[Docket No. FAA-2006-24074; Directorate Identifier 2005-NM-213-AD]

**Airworthiness Directives; Bombardier Model CL-600-2C10 (Regional Jet Series 700, 701, & 702) Airplanes, Model CL-600-2D15 (Regional Jet Series 705) Airplanes, and Model CL-600-2D24 (Regional Jet Series 900) Airplanes**

**ACTION:** Notice of proposed rulemaking (NPRM).

**Figure 1**  
**LH side shown**  
**RH side opposite**

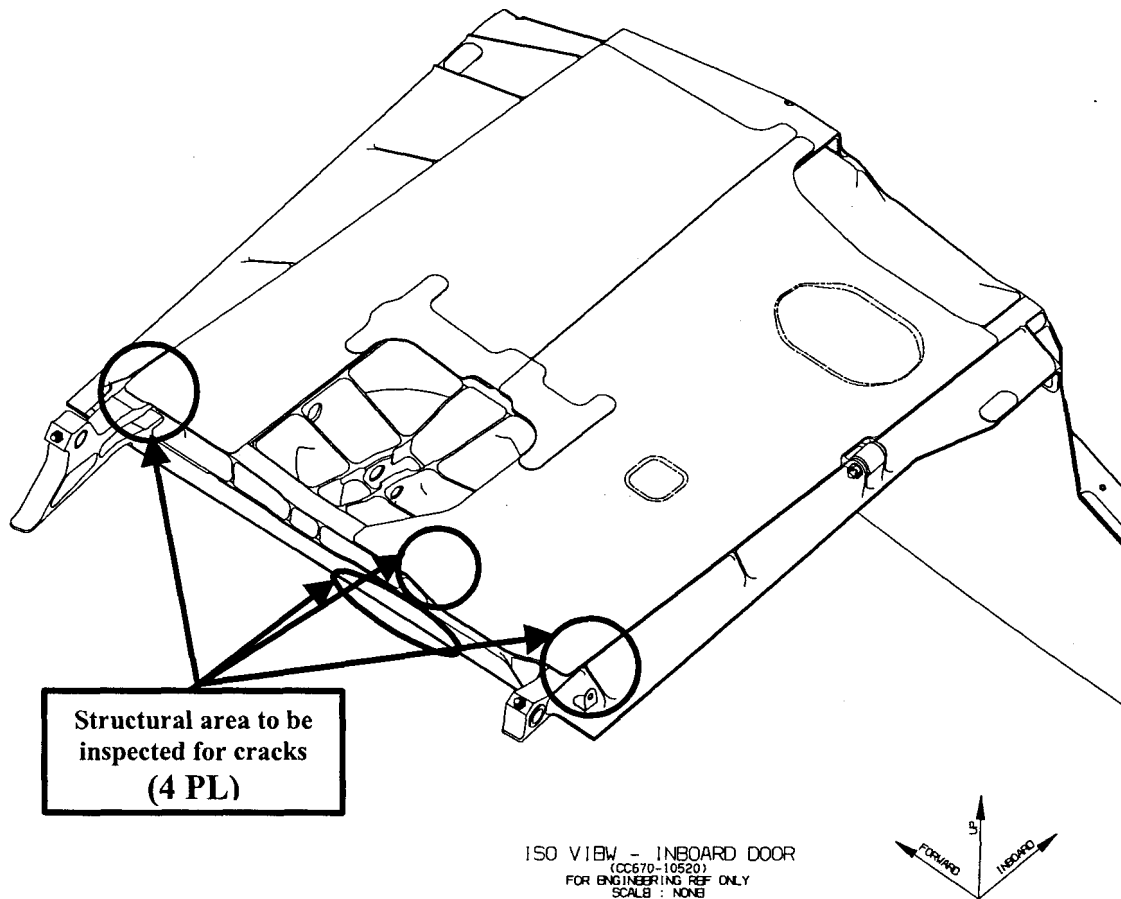
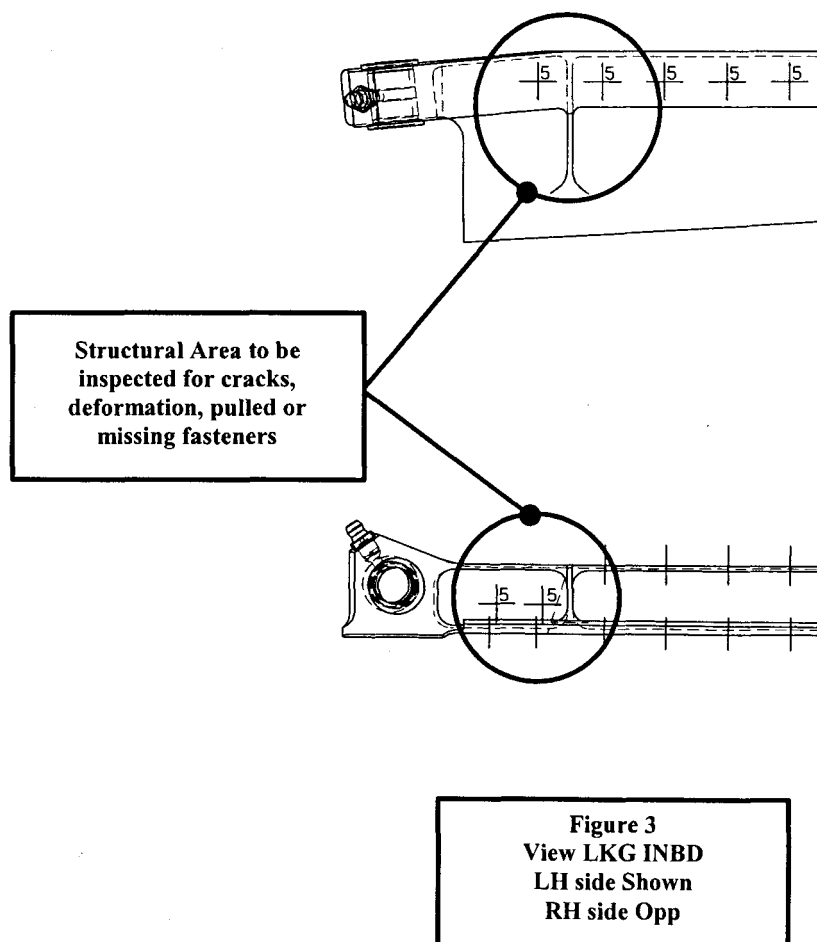
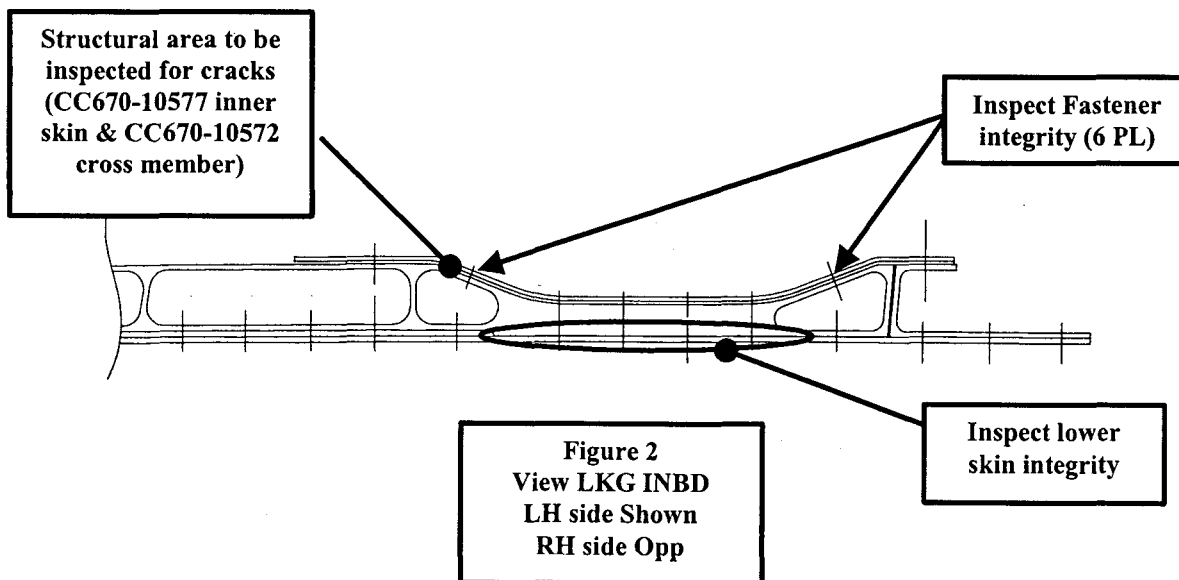
(1) Inspect the cross member, P/N CC670-10572, of the MLG door lower panel for cracking or deformation, in accordance with Figure 2 of this AD.

cross member (P/N CC670-10572) for cracking or deformation, or pulled or missing fasteners, in accordance with Figure 2 of this AD.

(3) Inspect the outer skin, P/N CC670-10574, of the MLG door lower panel at the cross member (P/N CC670-10572) for cracking or deformation, or pulled or missing

fasteners, in accordance with Figure 2 of this AD.

(4) Inspect the forward member, P/N CC670-10570, and aft member, P/N CC670-10571, of the MLG door lower panel, for cracking or deformation, or pulled or missing fasteners, in accordance with Figure 3 of this AD. Figures 1 through 3 of this AD follow.
